World Forum for Harmonization of Vehicle Regulations

Regulation No. 16 (Safety-belts).

Proposal for Supplement 1 to the 07 series of Amendments to Regulation No. 16 (Safety belts)

Submitted by the expert from France*

Figure 2

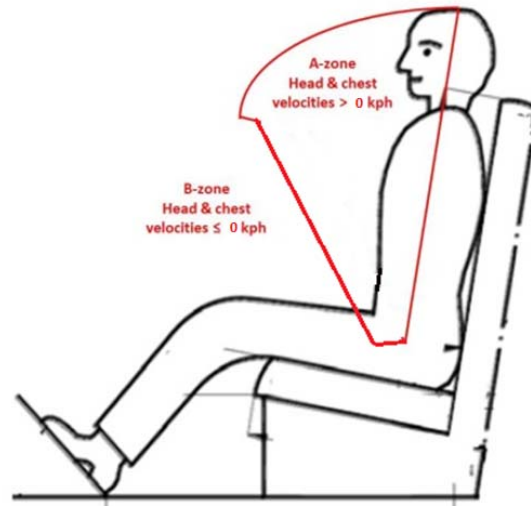
"12.1. In case a restraint system has been granted/extended, those can be used for particular types of vehicles compatible with the following dimensional conditions: no interior part in a quoted A-zone as shown below (Figure 2):

Figure 2
Installation of fixture onto vehicle seat
 (see paragraph 2.6.1.)

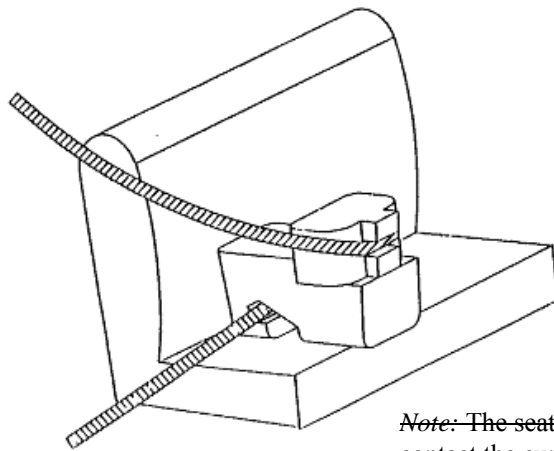
- "3.2. The lap portion of the belt shall touch the fixture on both sides at the rear of the lap belt path (see Figure 3). **The seat belt webbing shall always cover the points BP on the left and right ends of the curved edge; the exact position of point BP on the curved edge is indicated in detail W of Figure 1.**

Figure 7
Reduced-Size Rearward Facing toddler CRS Envelope dimensions for a reduced-size rearward-facing CRS, modified for improved compatibility with the vehicle interior

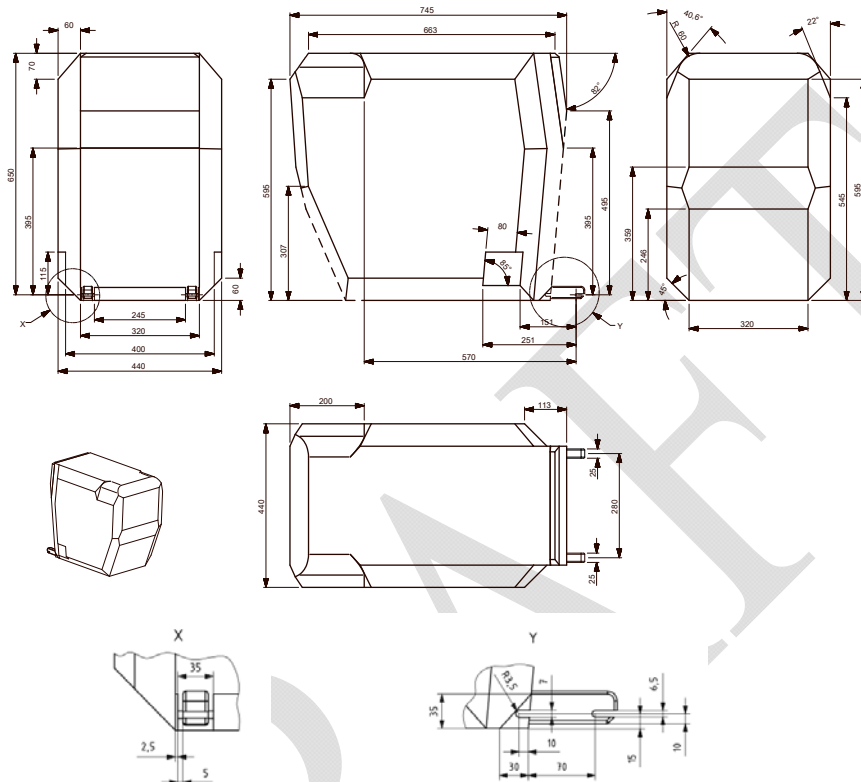
Annex 17, Appendix 2, insert new paragraph 4.7. and new Figure 7 to read:

"4.7. Rearward facing infant child restraint systems envelope ISO/R2X

- 1 limits in the rearward and upward directions
- 2 dashed lines mark the area where an anti-rotation device, or similar (e.g. rebound bar), is allowed to protrude
- [3 the backward limitation (to the right in the figure) is given by the forward-facing envelope in Figure 2]
- 4 further specifications of the connector area, see detail Y and ISO 13216-1:1999, Figures 2 and 3."

Figure 78
 Envelope dimensions for lateral facing position CRS - ISO/L1- ~~ISOFIX SIZE CLASS F~~ or symmetrically opposite - ISO/L2 (figure shown) ~~ISOFIX CLASS G~~

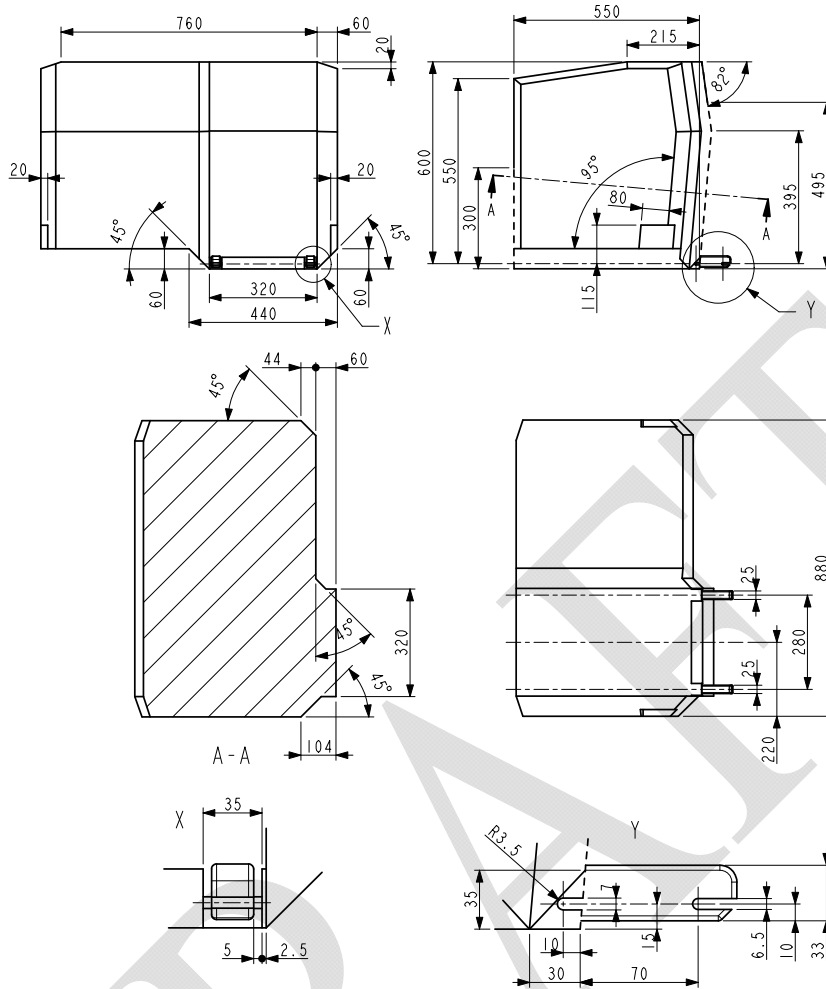
Annex 17, Appendix 2, paragraph 4.7 (former), renumber as paragraph 4.8. and amend to read:

"4.78. Lateral facing child restraint systems envelope

Note: The envelope for a left lateral-facing infant CRS (ISO/L1) has dimensions symmetric to ISO/L2 with regard to its intermediate longitudinal plan.

- 1** limits in the rearward and upward directions
- 2** dashed lines mark the area where an anti-rotation device, or similar (e.g. rebound bar), is allowed to protrude."

Figure 1
Positioning in Seat

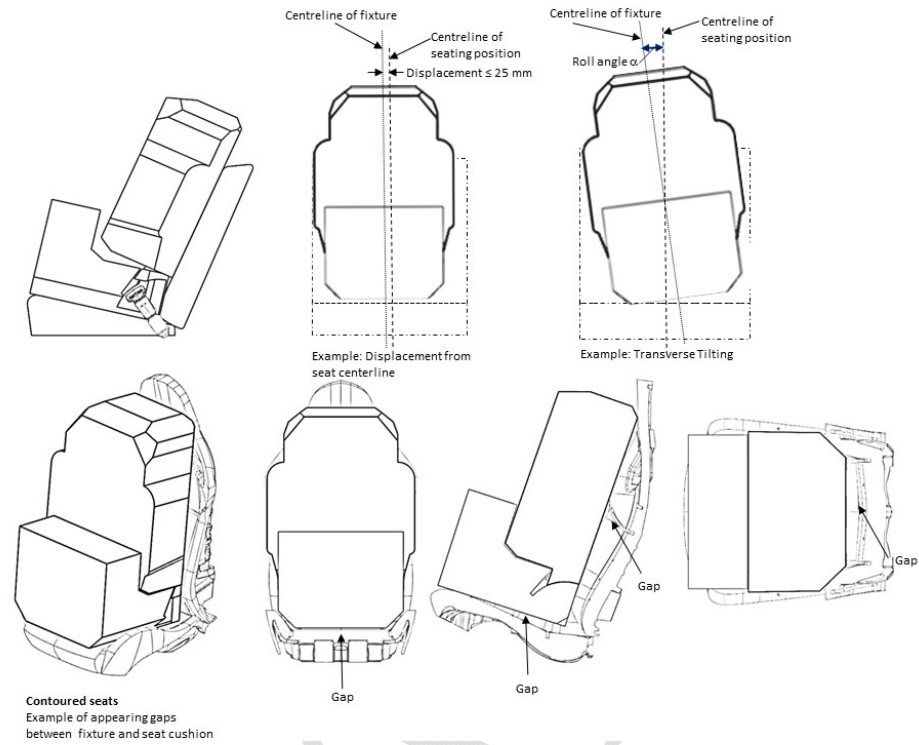
- 2.10. Ensure that the fixture is located with its centreline on the apparent centreline of the seating position ± 25 mm with its centreline parallel with the centreline of the vehicle seat. The roll angle α (see figure 1) shall be within $0^\circ \pm 5^\circ$

3. Requirements
- 3.1. It shall be possible to secure the fixture in the seating position using the 3-point seat belt and to buckle up the seat belt.
- 3.2. The roll angle α as shown in Figure 1 shall be equal to or less than 5° .

- 3.3. The base of the fixture shall be in contact with the seat cushion, and the back face of the fixture shall be in contact with the seat back or head restraint. Full contact with the seat is not necessary, "gaps" due to the vehicle seats contours are permitted as shown by the arrows in Figure 1. The booster seat envelope is equipped with an adjustable backrest. Compatibility with the vehicle seating position shall be achieved in at least one position of the backrest range shown in Figure 2 or Figure 3.

Figure 2
ISO/B2: Envelope dimensions for booster seat, reduced width 440 mm - without ISOFIX, or with connectors removed or stowed within the body of the fixture (behind line E, as defined by detail B).

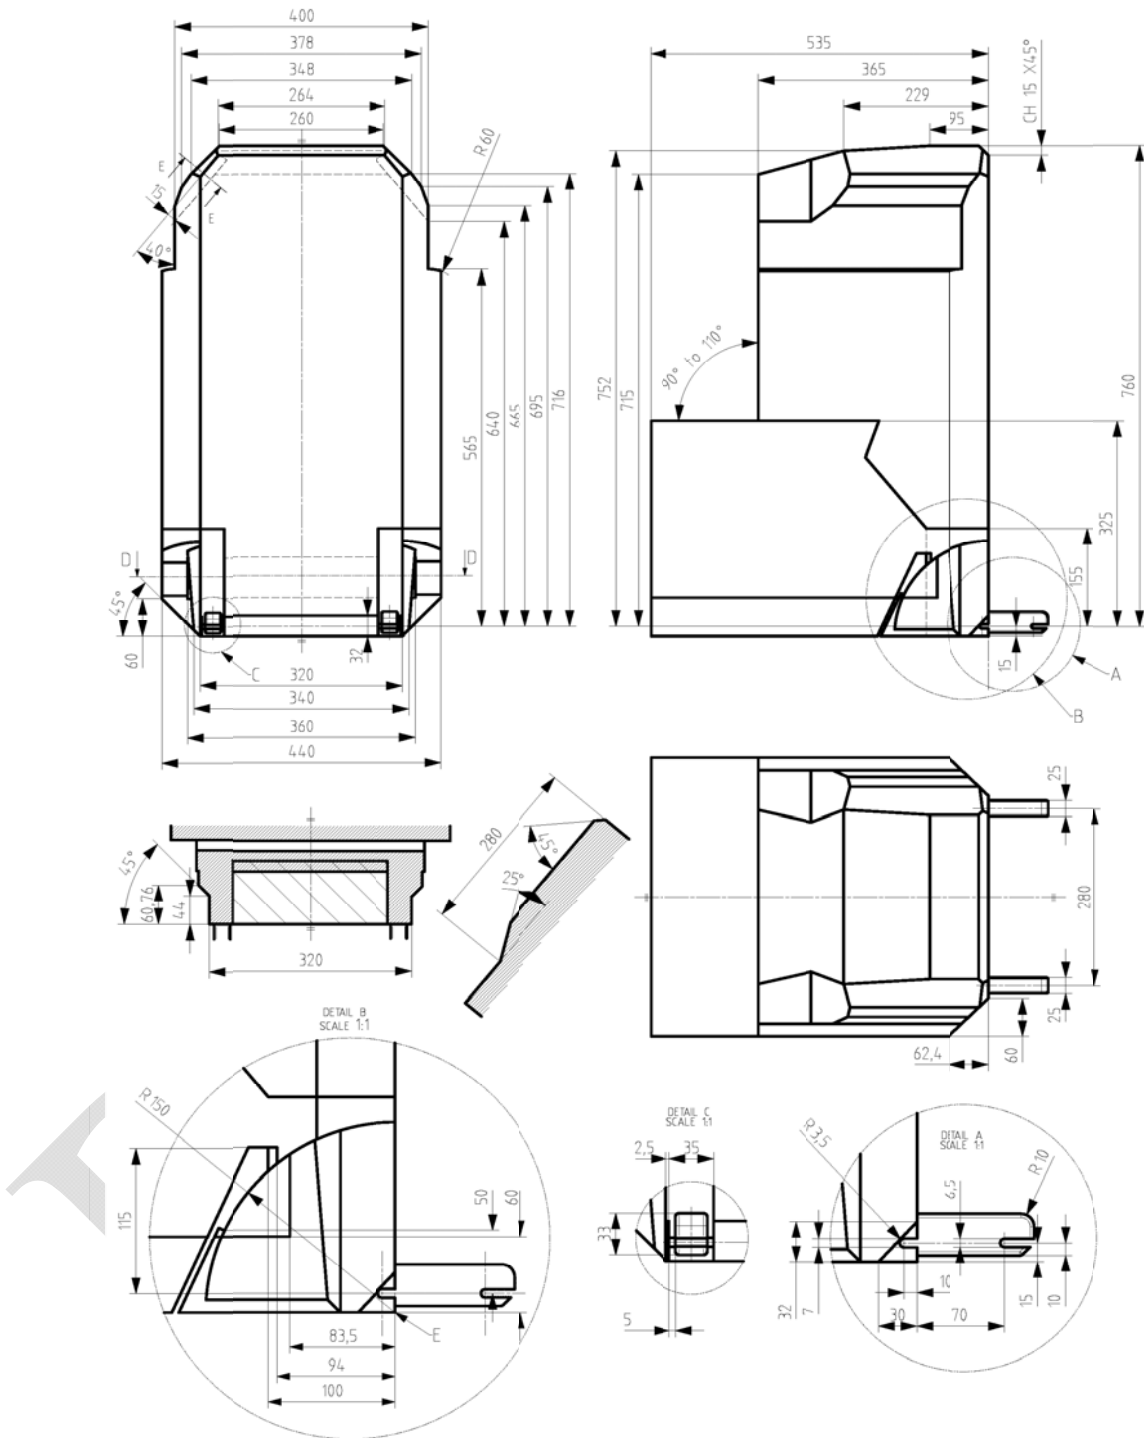
Annex 17, insert new Appendix 5 to read:

4. Booster seat child restraint system fixtures:
- ISO/B2: Booster seat, reduced width 440 mm (figure 2)
 - ISO/B3: booster seat, full width 520 mm (figure 3)

Key **E** is the Reference axle of rotation of the backrest (90° to 110°) and reference line for retraction/stowing of ISOFIX
